BAR 22-04-01
864 Locust Avenue, Tax Parcel 510093000
Martha Jefferson Historic Conservation District
Owner/Applicant: Elvira Hoskins
Project: New accessory structure

**City of Charlottesville
Board of Architectural Review
Staff Report
April 19, 2022**

BAR 22-04-01

Project: Studio

1 ARCHITECTURAL SITE PLAN
1 1/32" = 1'-0"

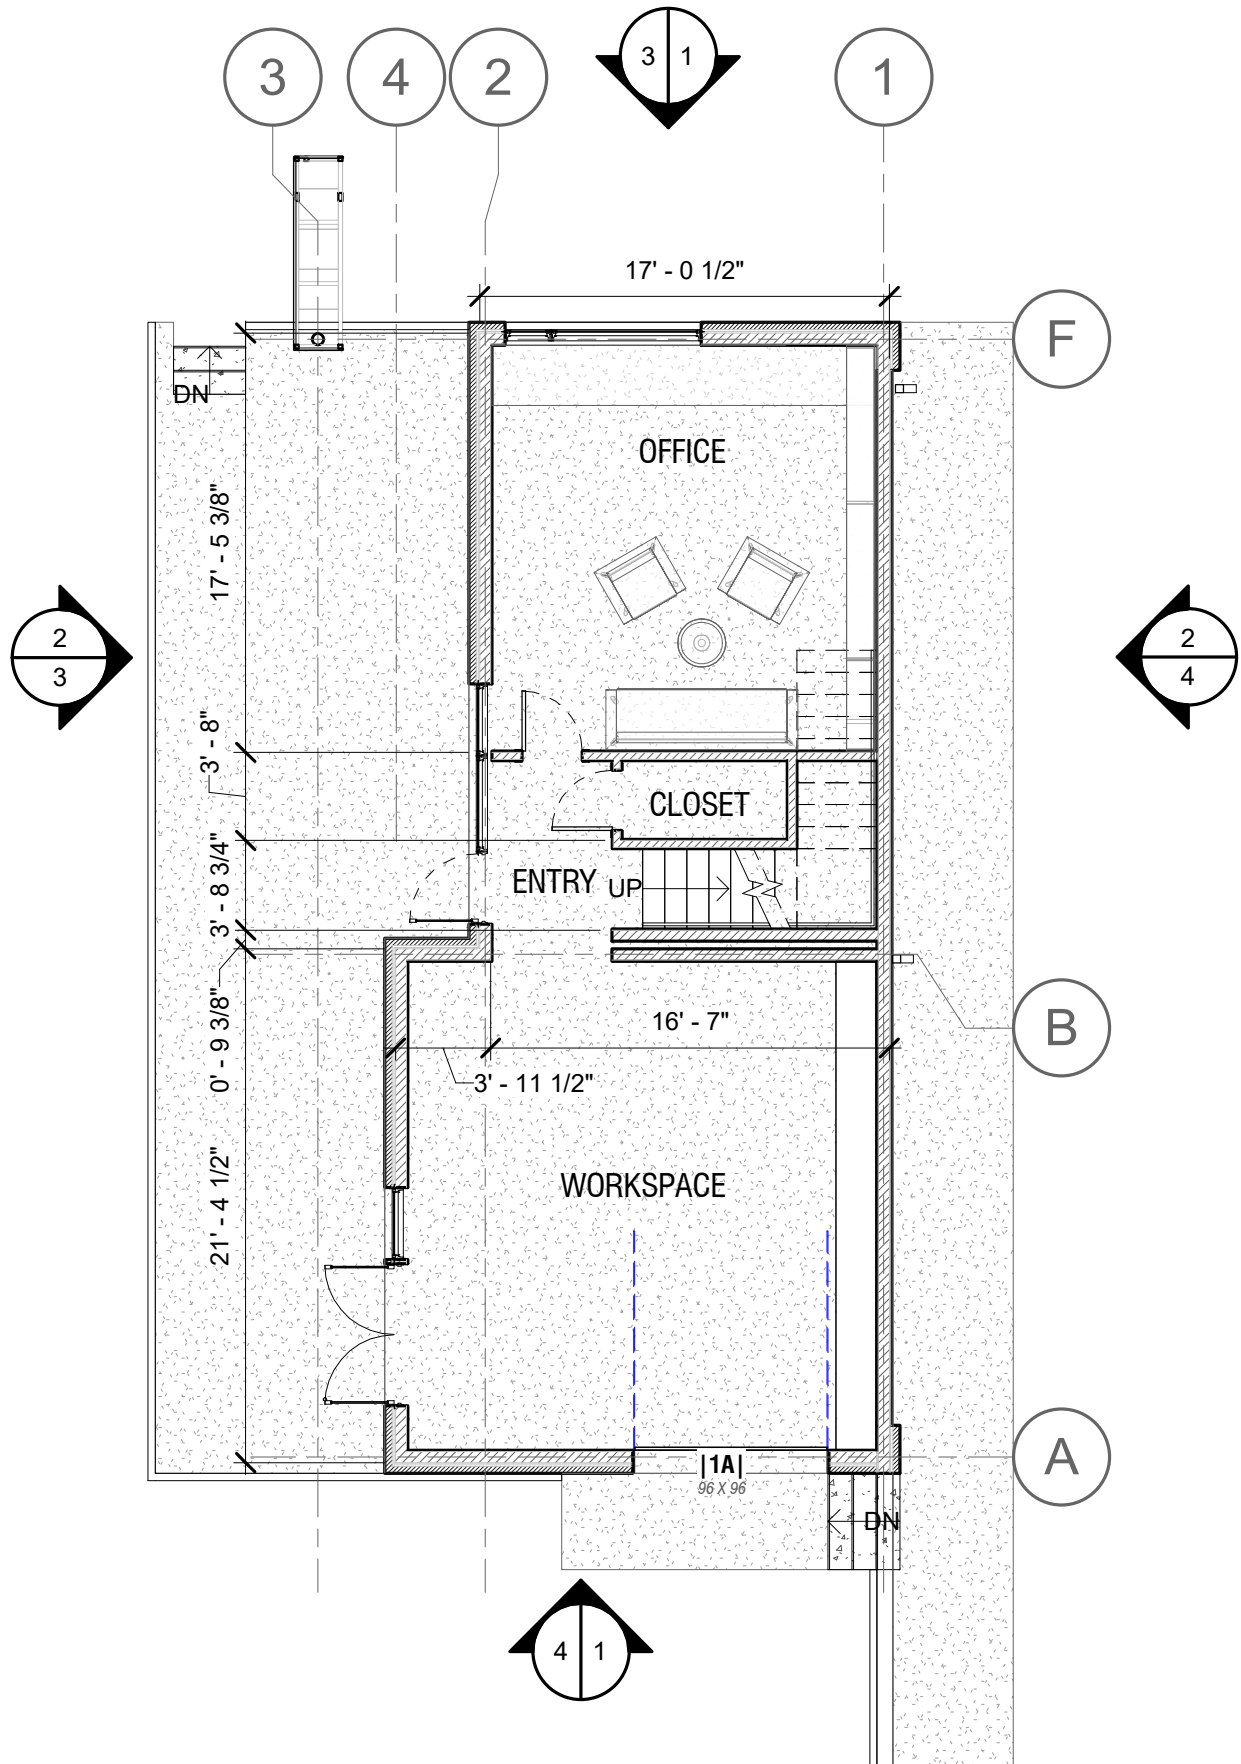
Staff Comment: Proposed structure is located in the rear yard and features a standing-seam metal roof.

1
4 ELEVATION - WEST
1/8" = 1'-0"

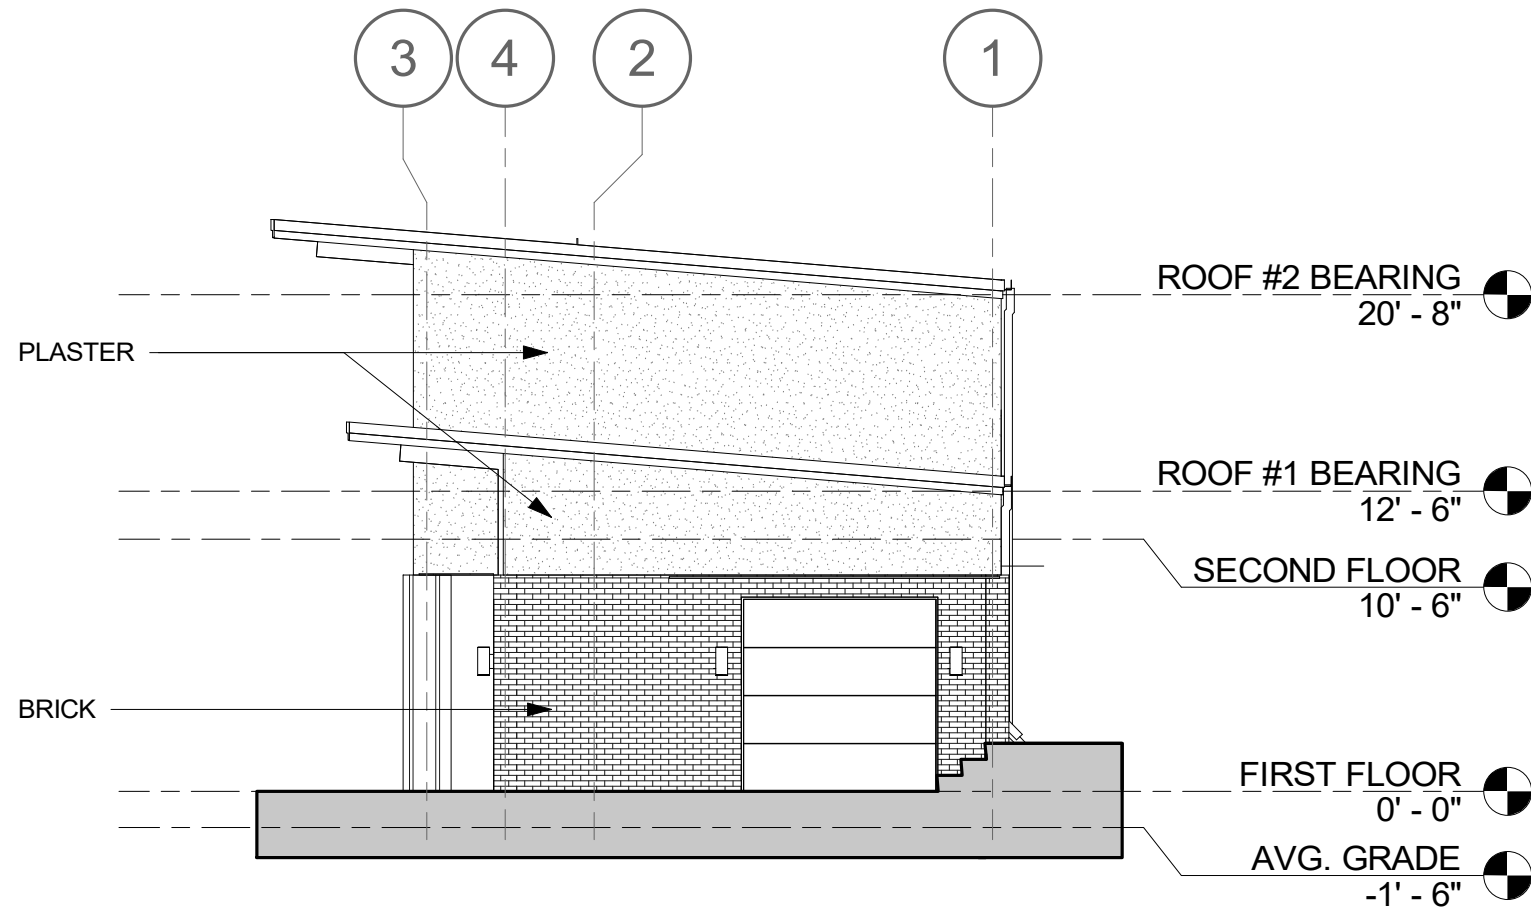
Within an HCD, the design review prioritizes what is visible from the public right of way. New structures concealed by the principal structure from all abutting streets are exempt from BAR review. With that, the four sides of the proposed garage are of the same design and materials, staff will focus on the front elevation.

Staff Comment: Like many historic garage buildings in the Martha Jefferson neighborhood, the elevation facing the street contains a single garage door opening.
